SUBJECT: Initial review of Planned Rezoning Overlay (PRO) eligibility of the request of Jax Kar Wash, JZ24-02, to rezone property at the southeast corner of Twelve Mile Road and Cabaret Drive from Regional Center to General Business with a Planned Rezoning Overlay.

SUBMITTING DEPARTMENT: Community Development Department - Planning

PRO Concept Plan: Consideration of Eligibility
 Rezoning Request from RC Regional Center to B-3 General Business with a Planned Rezoning Overlay

ORIGINAL ISSUE DATE:
 FEBRUARY 9, 2024
 DRAWING TITLE
LANDSCAPE CALCULATIONS

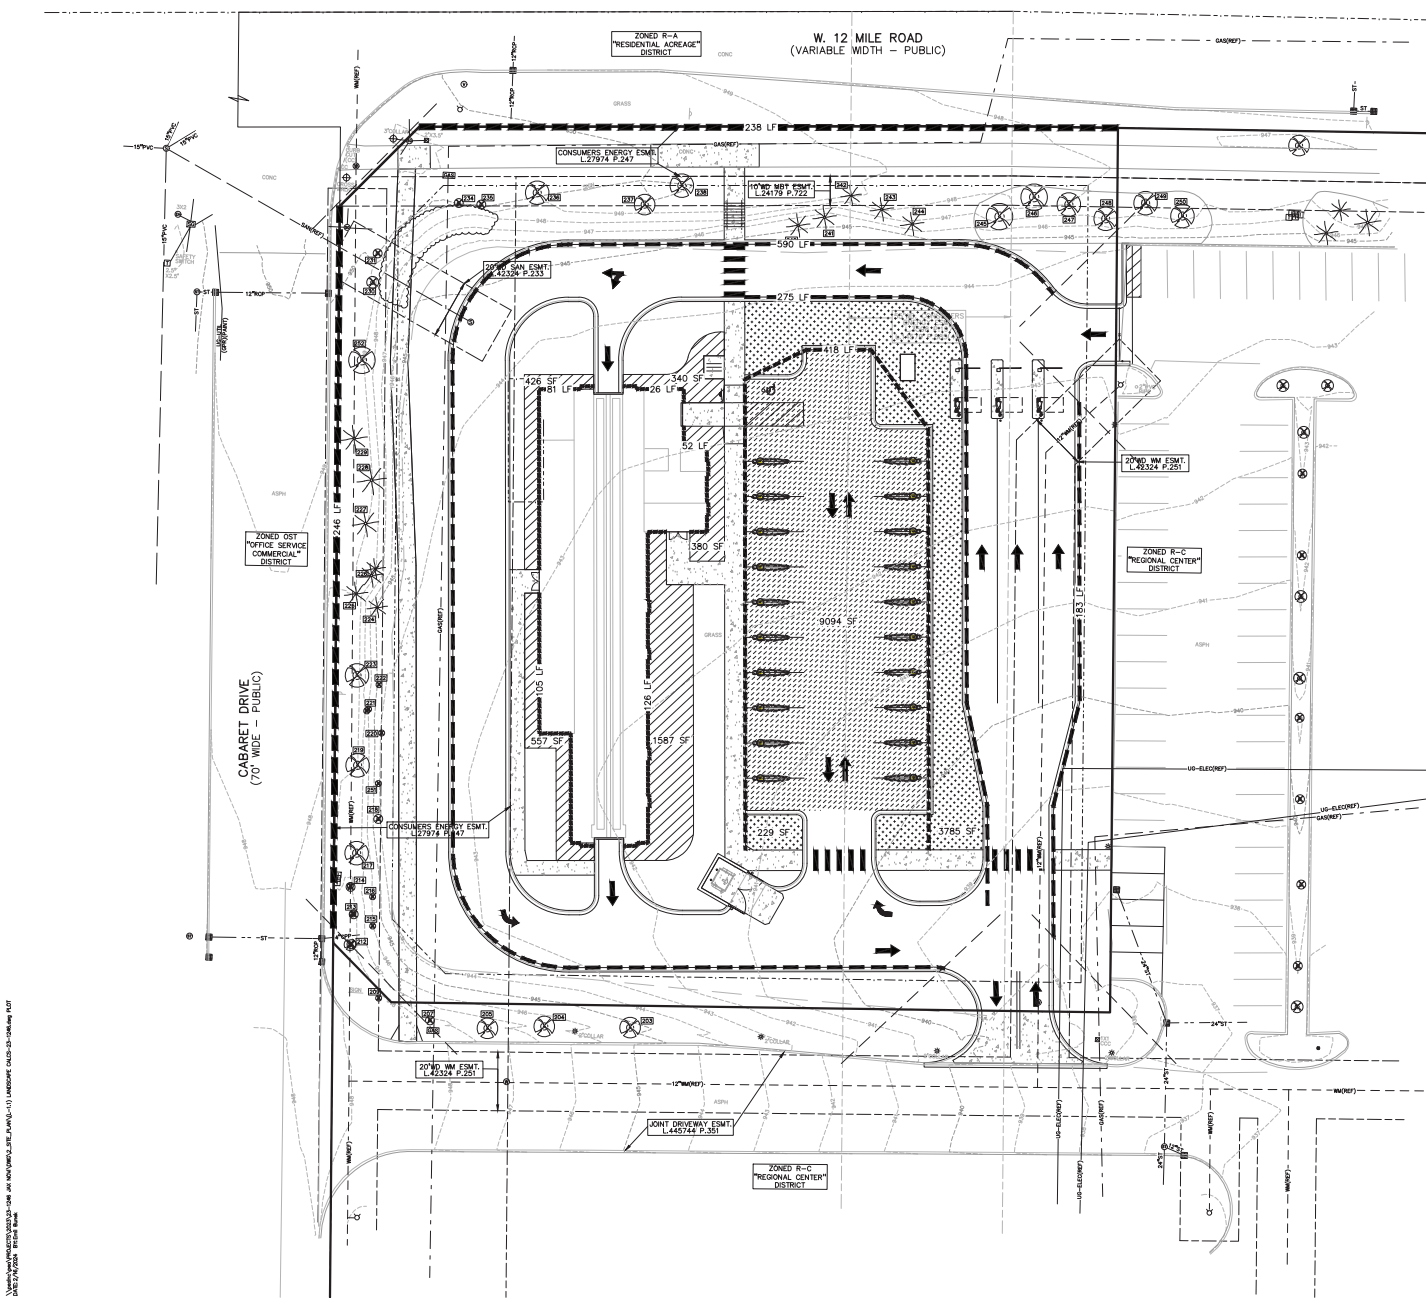
6. Parking Lot Landscaping (Section 5.5.3.C): Deviation would be required for not providing the required number of accessway perimeter trees. **The deviation is not supported by staff, unless the applicant can provide sufficient justification for the deficiency. The applicant's response letter states the two existing utility easements do not permit the planting of landscaping in those easement areas.**

DATE:	ISSUED FOR:
DRAWING DATE:	1-17-24
PROJECT NUMBER:	22109
SHEET NUMBER:	PE-1A

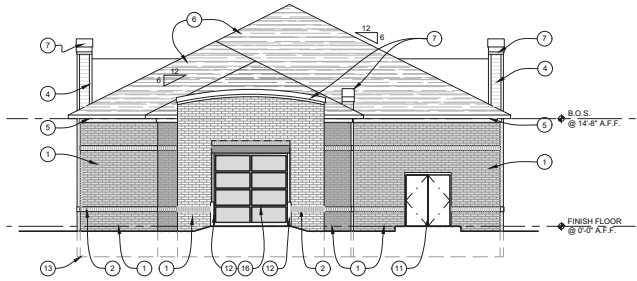
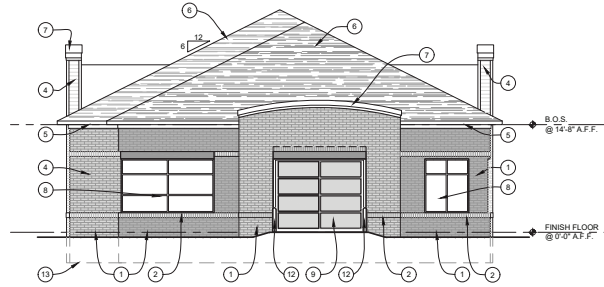
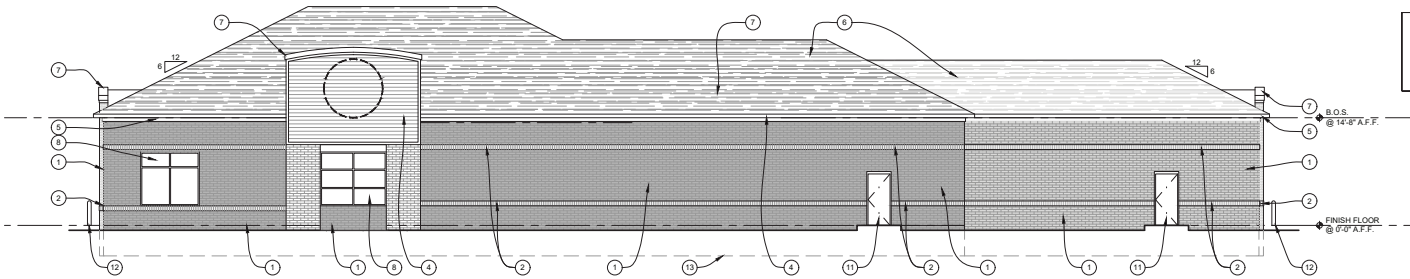
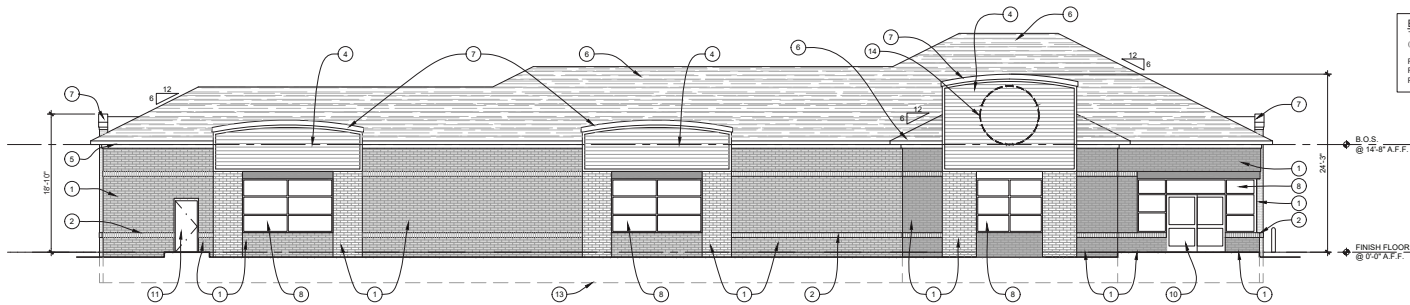
8. Section 9 Waiver (Section 5.15): Proposed elevations of the building have an overage of Horizontal lap siding (8-10% proposed, 0% minimum required) and an overage of Asphalt Shingles (31-36% proposed, 25% maximum allowed). **In this case the deviations are not detrimental to the overall design of the building, and consistent with the intent and purpose of the Ordinance.**
